## Product Change Notice (PCN)

**PCN Number:** PCN-0451320R-01

**Product(s) Affected:** PDP-30

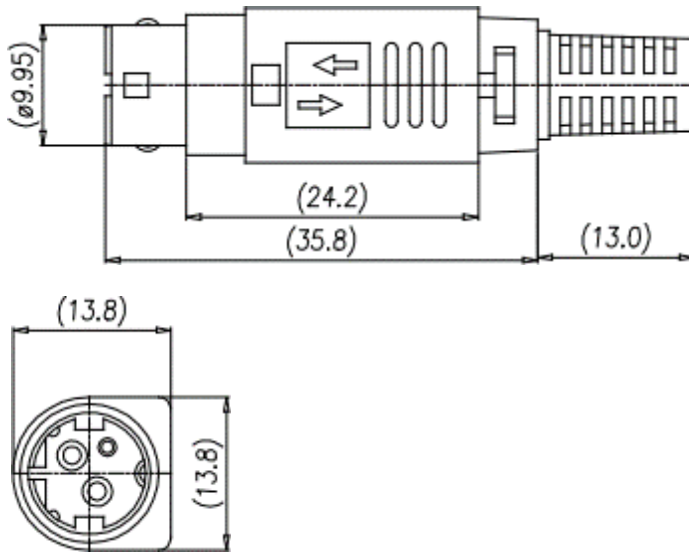
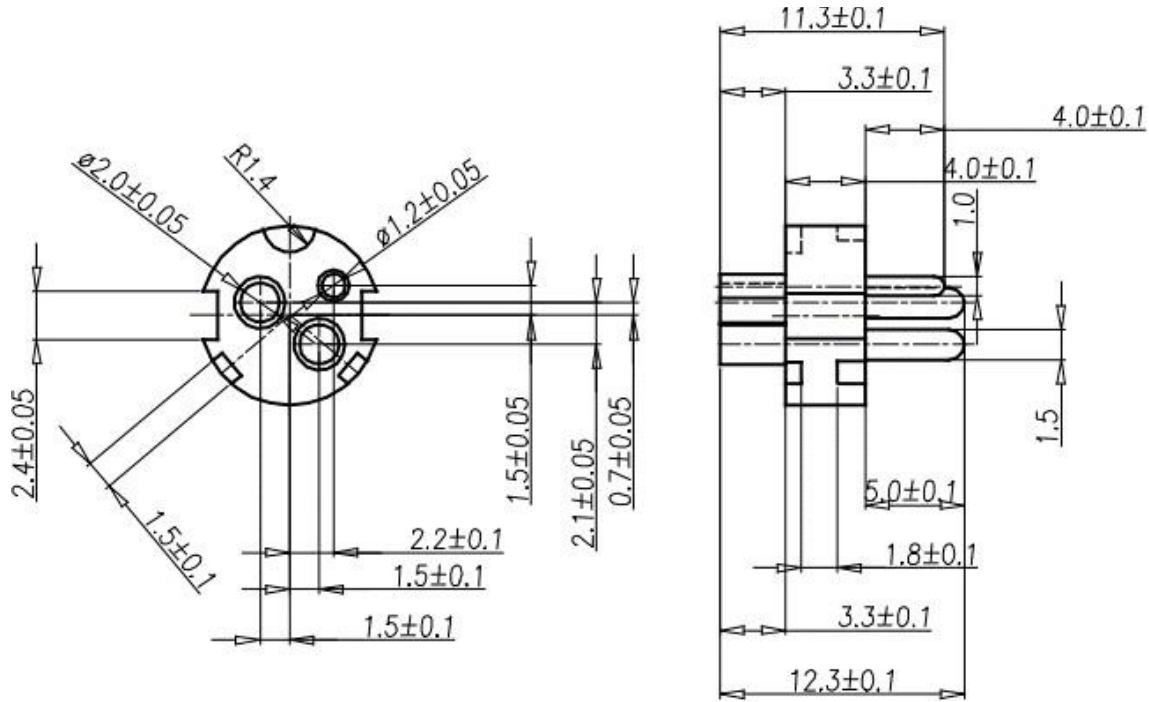
**Description of Change:** housing and materials changes as shown below.

MATERIAL	PLATING
OUTER HOOD	ABS	
METAL SLEEVE	Brass	Nickel
CLAMP	Brass	Nickel
PIN/BODY	Brass/PBT	Silver
PLASTIC RING	POM	
METAL COVER	Brass	Nickel
SPRING	Steel	
INNER HOOD	ABS	
STRAIN RELIEF	PVC

MATERIAL	PLATING
housing	PBT (UL94V-0)	
contacts	copper alloy	silver
plastic cover	ABS	
metal shell	copper alloy	nickel
metal cap	copper alloy	nickel
cable fixer	copper alloy	tin
ring	POM	
spring	steel	nickel
plastic tube	ABS	
SR	PVC
